Access Compliance Report

Public Rights-of-Way

Intersection ID: 16513	Main Street: BILTMORE_DR	Cross Street: COLVILLE_RD	Location: NW
ADA ID: 5515212646CA	Ramp Type: Perp	Initial Pass/Fail: Fail	Overall Compliance: No
		Severity Score: 22.5

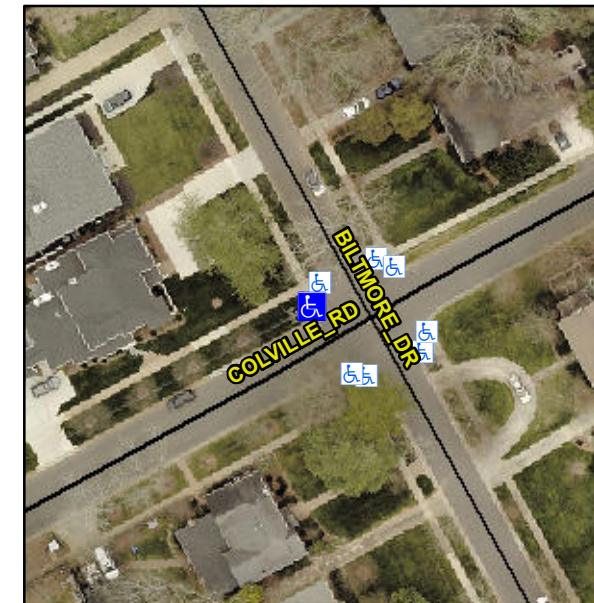
Not Found, R304.5.1, R304.2.2, R304.5.3

Compliance	Description	Data	Compliance	Description	Data
N/A	Ramp Length (in)	58.0	No	Ramp Slope (%)	10.0
No	Ramp Width (in)	36.0	No	Ramp XSlope (%)	3.6
N/A	Flare Type LT	N/A	N/A	Flare Type RT	N/A
N/A	Flare Slope LT (%)	N/A	N/A	Flare Slope RT (%)	N/A
N/A	Flare Traversable LT?	N/A	N/A	Flare Traversable RT?	N/A
N/A	Landing Length (in)	N/A	N/A	DWS Provided?	N/A
N/A	Landing Width (in)	N/A	N/A	DWS Contrast?	N/A
N/A	Landing Slope (%)	N/A	N/A	DWS Length (in)	N/A
N/A	Landing X Slope (%)	N/A	N/A	DWS Full Width?	N/A
N/A	Landing Curb? (Y/N)	N/A	N/A	DWS Offset (in)	N/A
N/A	Shared Landing?	N/A			
N/A	Gutter Ponding?	N/A	N/A	Gutter Slope (%)	N/A
N/A	Gutter Lip Ht (in)	N/A	N/A	Gutter X Slope (%)	N/A
N/A	Painted X Walk1?	No	N/A	Painted X Walk2?	N/A
	X Walk 1 Direction	To S		X Walk 2 Direction	N/A
N/A	X Walk 1 Width (in)	N/A	N/A	X Walk 2 Width (in)	N/A
	X Walk 1 Slope (%)	3.5		X Walk 2 Slope (%)	N/A
	X Walk 1 X Slope (%)	2.3		X Walk 2 X Slope (%)	N/A

Remove & Replace Entire Ramp.
